January 19, 2024

**LINCOLN PUBLIC SCHOOLS
ARTS & HUMANITIES FOCUS PROGRAM – ENHANCEMENT PROJECT
LINCOLN, NEBRASKA**

ADDENDUM #1

C1.0

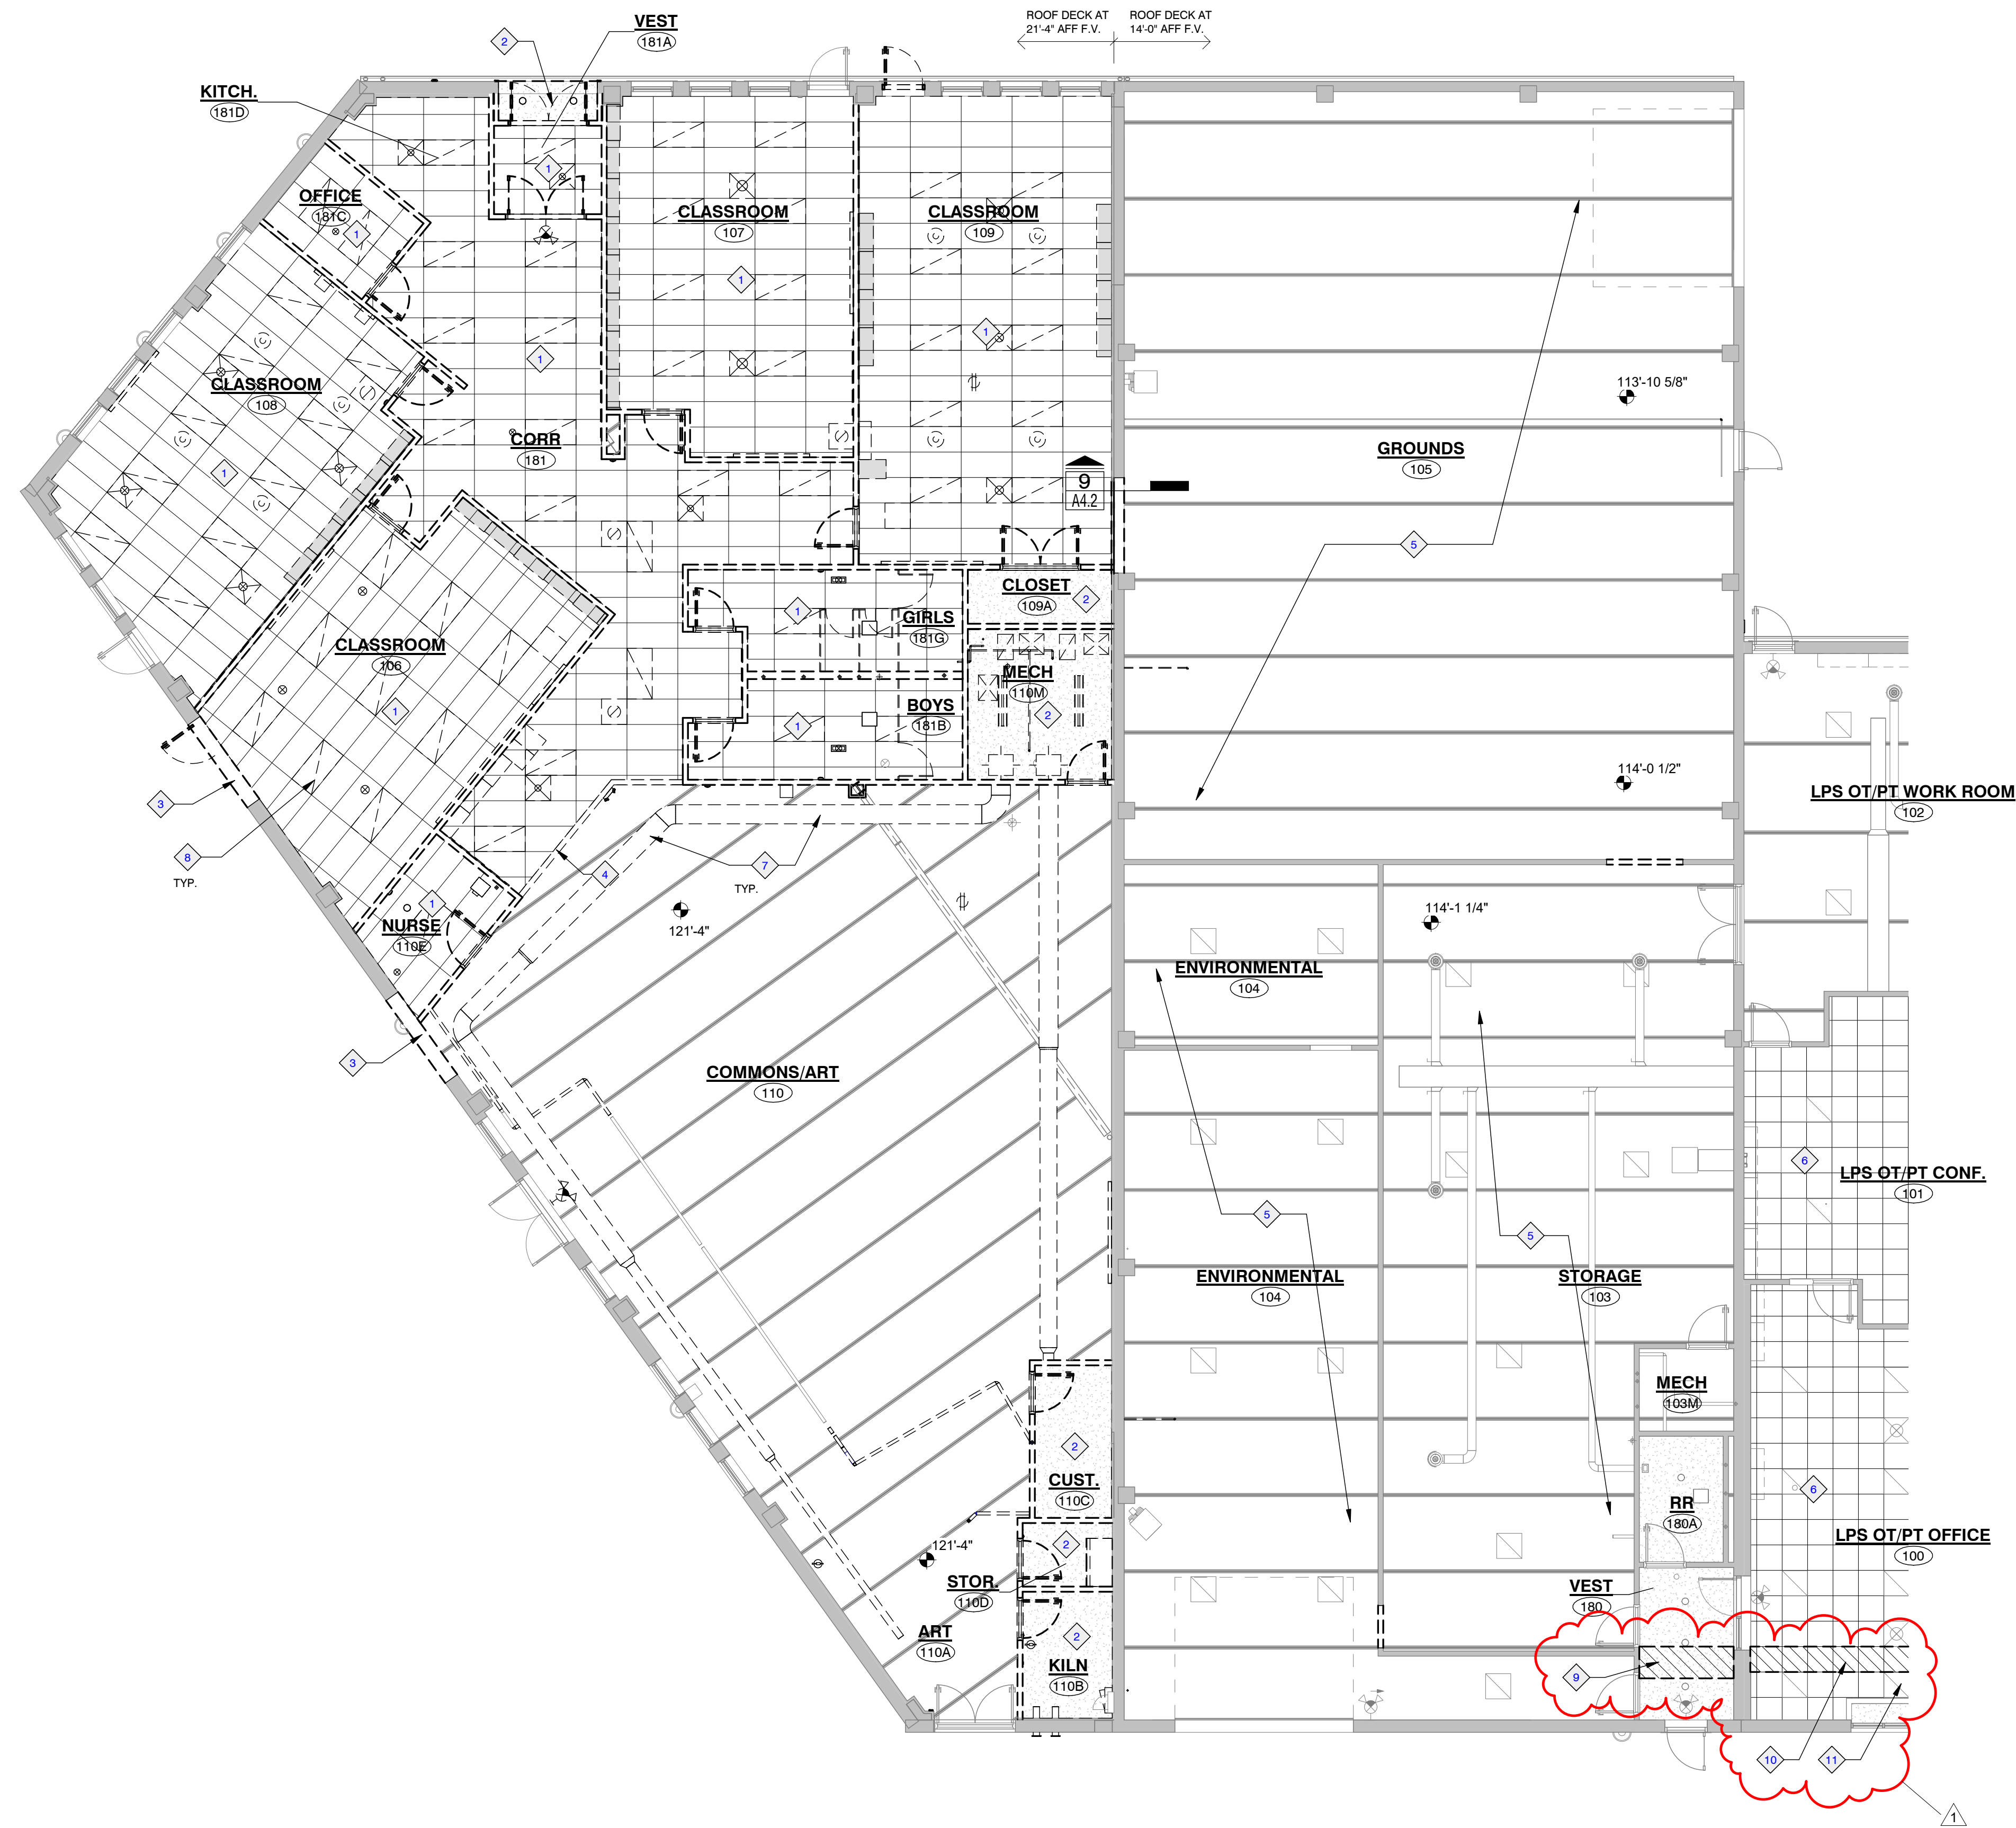
Item No. 1-5: **Sheet C1.0 – Site Plan & Det's**

- A. At 'Site Overall Plan – Detail 1', Add a note to include 2 galvanized steel pipe bollards at the area of the PIV and FDC as shown on Sheet P2.1.

D1.3
DEMO RCP

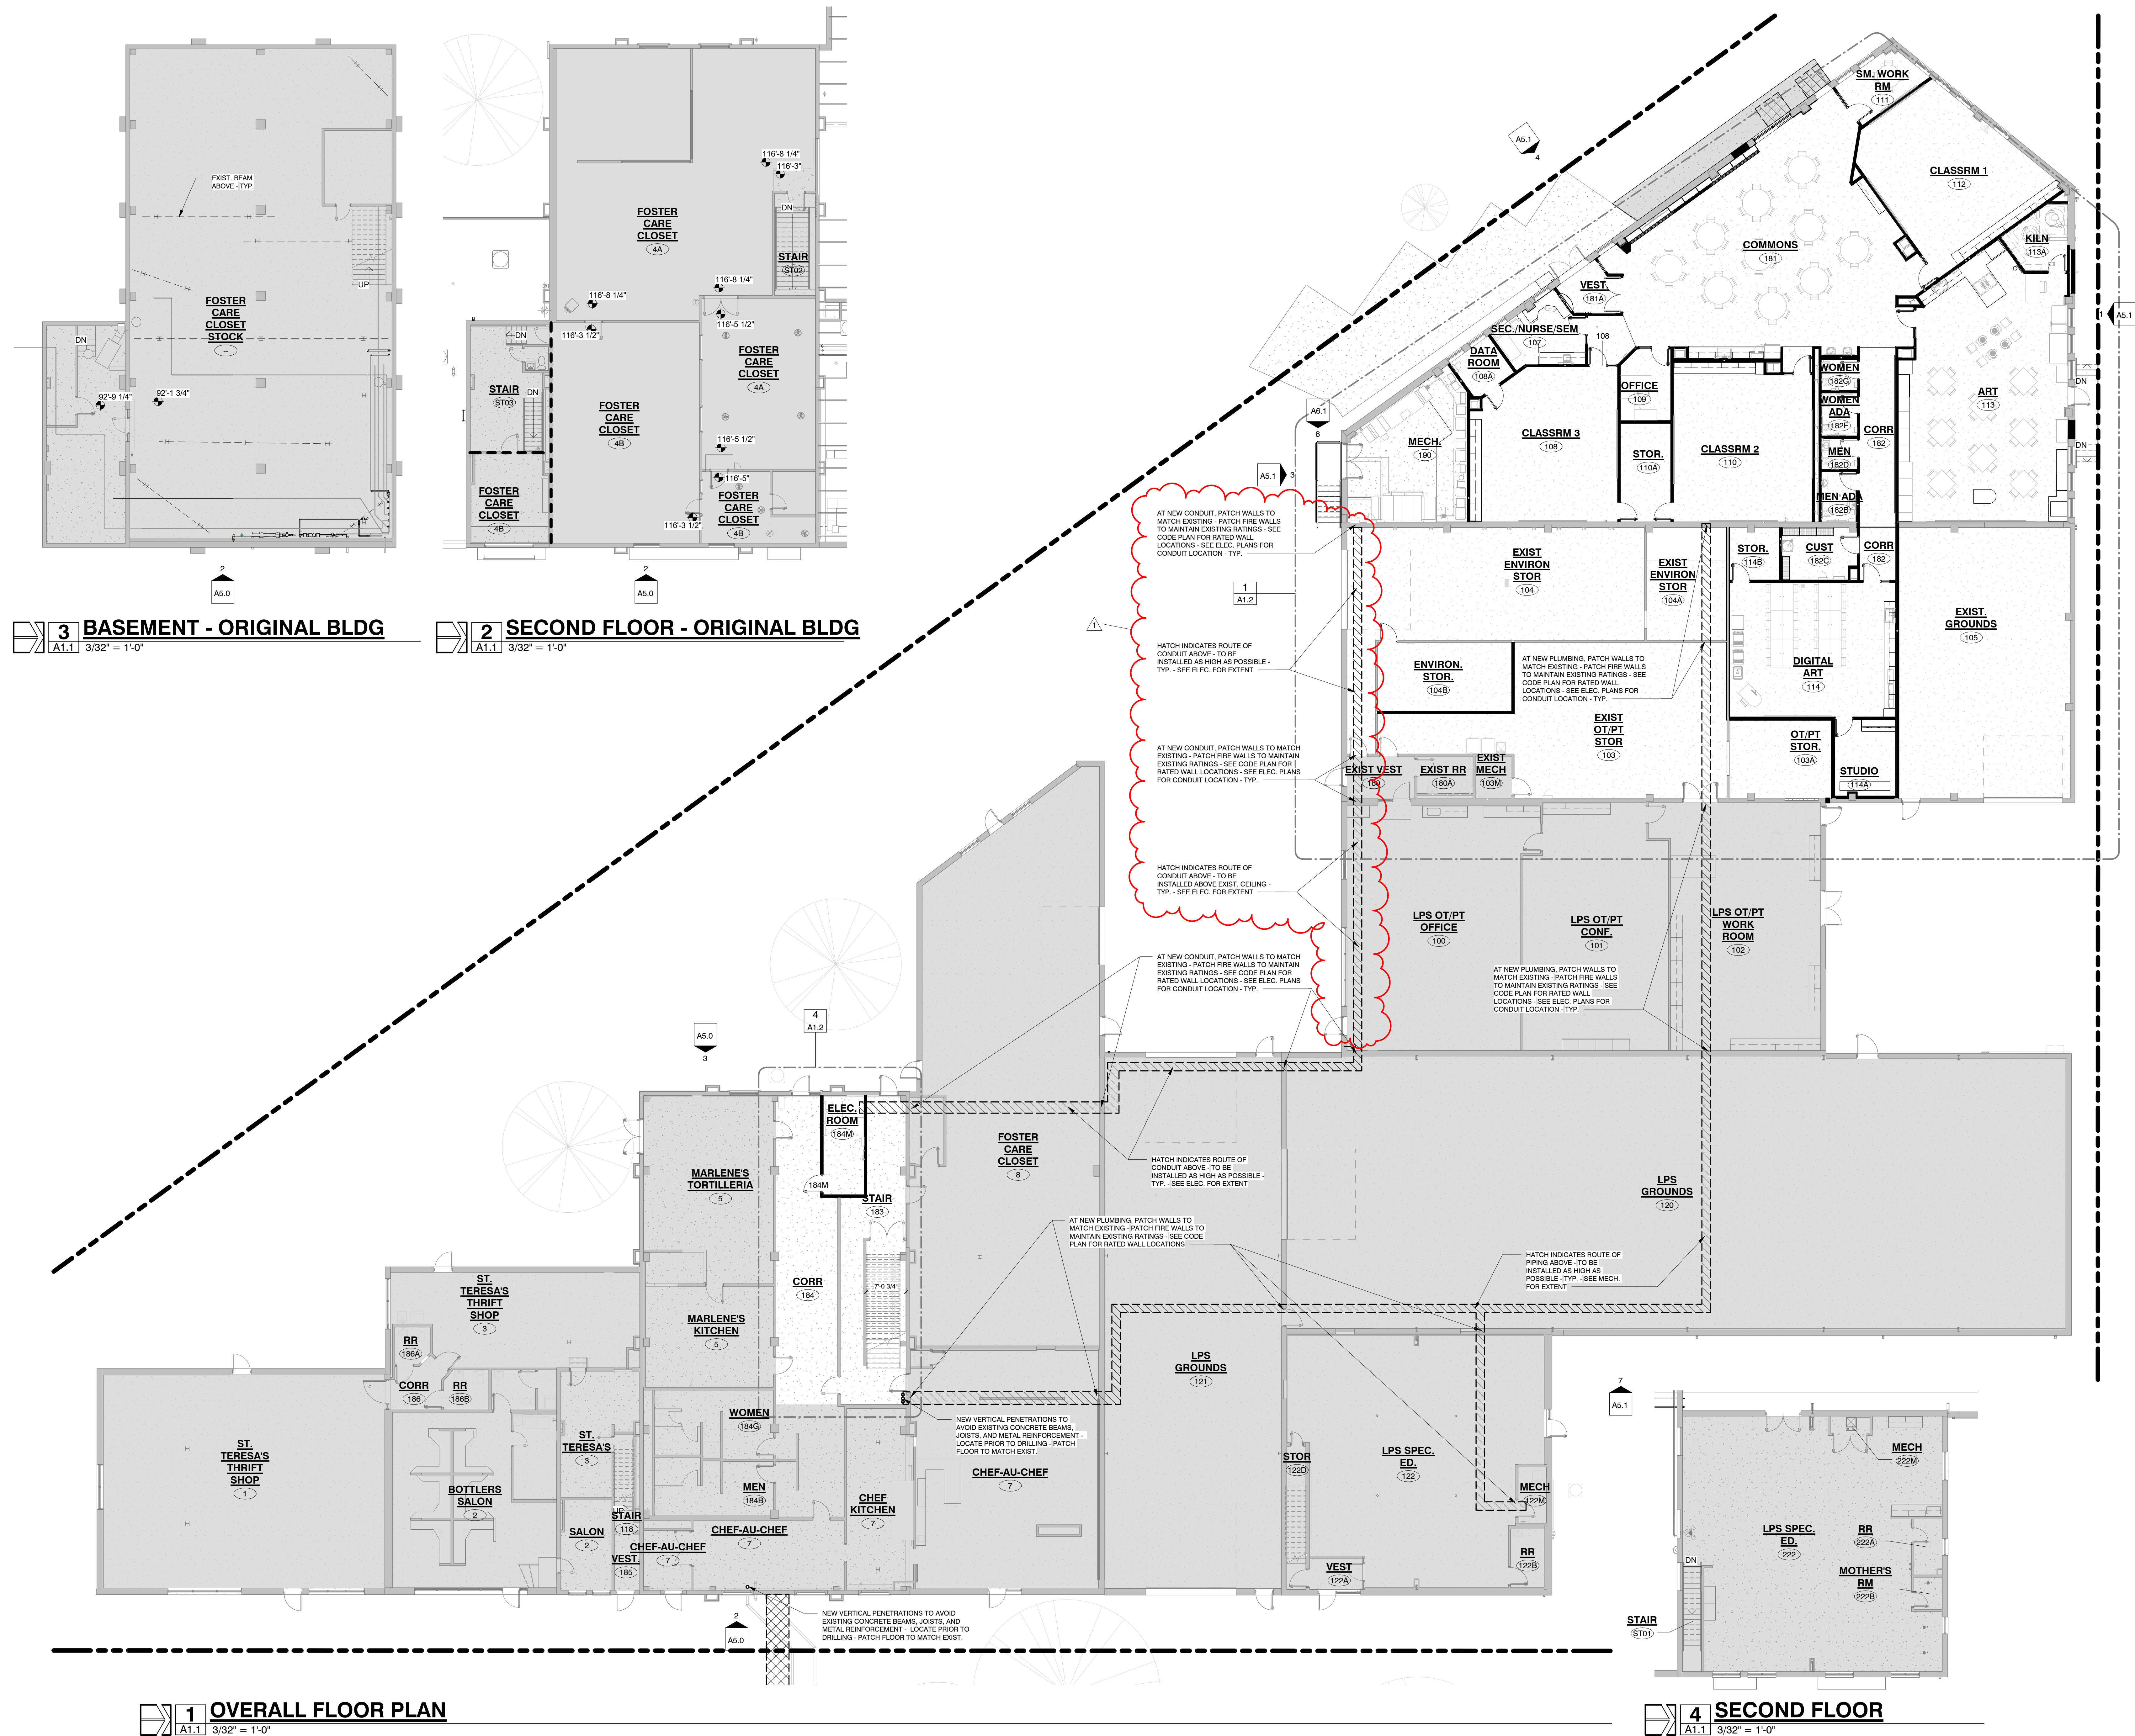
Item No. 1-6: **Sheet D1.3 – RCP Demo**

- A. At 'Reflected Ceiling Plan – Detail 1', At OT/PT Office 100, Remove and salvage ceiling pads, grid and lights as needed to install electrical and fiber conduit. See Elec and Sheet A3.0 for extent and location of conduit.
- B. At 'Reflected Ceiling Plan – Detail 1' – At Vest. 180, Remove gyp board ceiling as needed to install electrical and fiber conduit. See Elec and Sheet A3.0 for extent and location of conduit.

4 ELECTRICAL ROOM RENO.

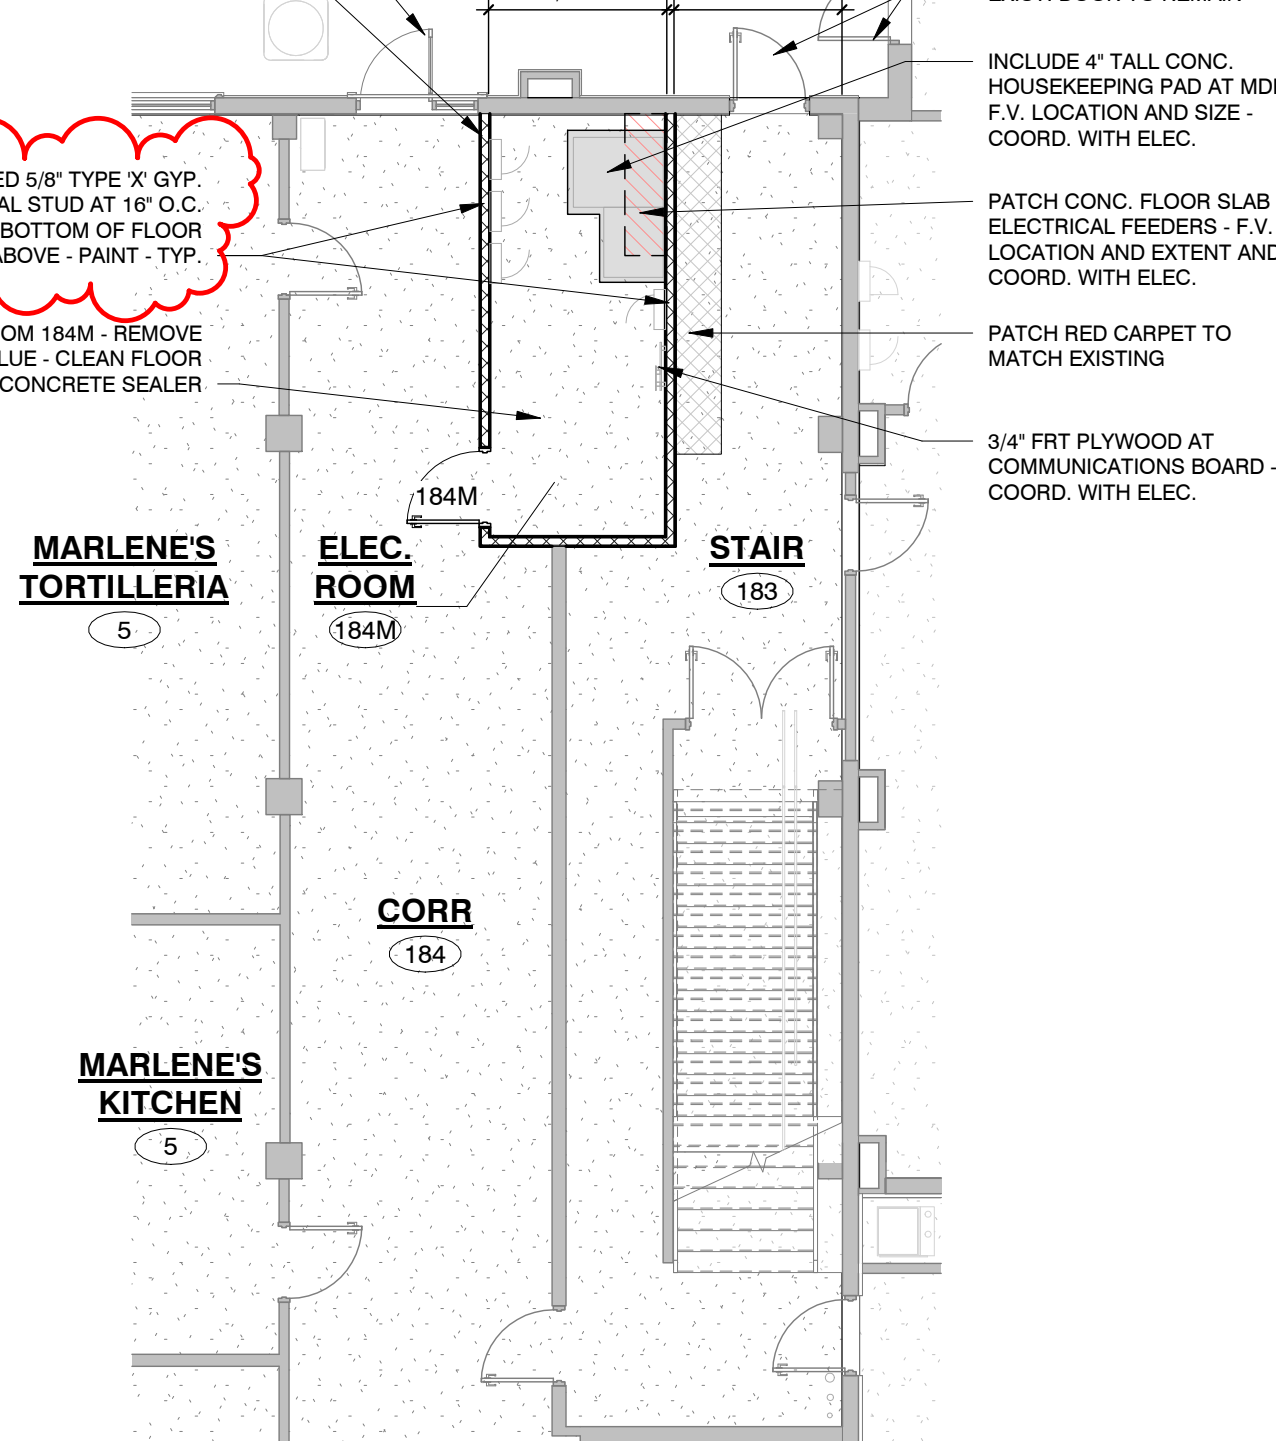
Item No. 1-8:**Sheet A1.2 – Floor Plans**

- A. At 'Electrical Room Reno Plan – Det 4', At Elec Room 184M walls, add the following note: "1-hour fire rated with 5/8" type 'x' gyp board on 3 5/8" metal studs at 16" o.c. from floor to floor slab above – paint – typ."
